Access Compliance Report

Public Rights-of-Way

Intersection ID: 10030537	Main Street: LITTLE ROCK RD	Cross Street: N/A	Location: NE
ADA ID: 99DCC85E2297	Ramp Type: BlendTrans2	Initial Pass/Fail: Fail	Overall Compliance: No
		Severity Score: 10

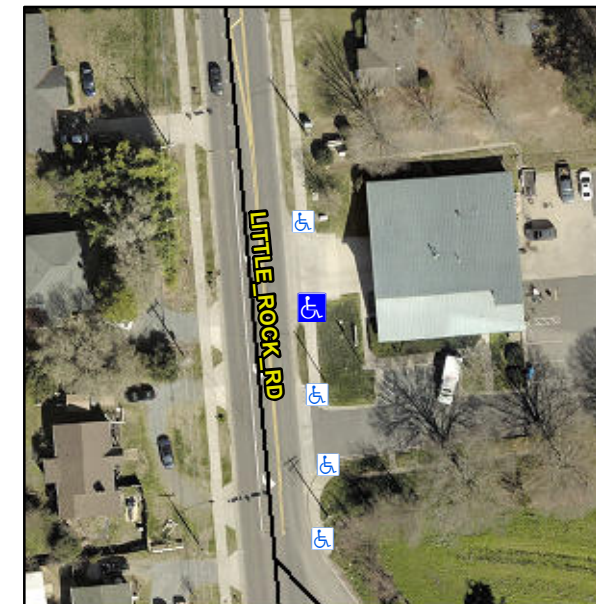
Not Found, R304.5.1, R304.5.3

Compliance	Description	Data	Compliance	Description	Data
N/A	Ramp Length (in)	90.0	Yes	BlendTrans Slope (%)	3.3
No	Ramp Width (in)	47.0	No	BlendTrans XSlope (%)	3.5
N/A	Flare Type LT	N/A	N/A	Flare Type RT	N/A
N/A	Flare Slope LT (%)	N/A	N/A	Flare Slope RT (%)	N/A
N/A	Flare Traversable LT?	N/A	N/A	Flare Traversable RT?	N/A
N/A	Landing Length (in)	N/A	N/A	DWS Provided?	N/A
N/A	Landing Width (in)	N/A	N/A	DWS Contrast?	N/A
N/A	Landing Slope (%)	N/A	N/A	DWS Length (in)	N/A
N/A	Landing X Slope (%)	N/A	N/A	DWS Full Width?	N/A
N/A	Landing Curb? (Y/N)	N/A	N/A	DWS Offset (in)	N/A
N/A	Shared Landing?	N/A			
N/A	Gutter Ponding?	N/A	N/A	Gutter Slope (%)	N/A
N/A	Gutter Lip Ht (in)	N/A	N/A	Gutter X Slope (%)	N/A
N/A	Painted X Walk1?	No	N/A	Painted X Walk2?	No
	X Walk 1 Direction	To N		X Walk 2 Direction	To W
	X Walk 1 Width (in)	N/A		X Walk 2 Width (in)	N/A
	X Walk 1 Slope (%)	0.3		X Walk 2 Slope (%)	3.2
	X Walk 1 X Slope (%)	2.4		X Walk 2 X Slope (%)	0.5

Remove & Replace Curb Ramp With Two New Directional Ramps or Equivalent.
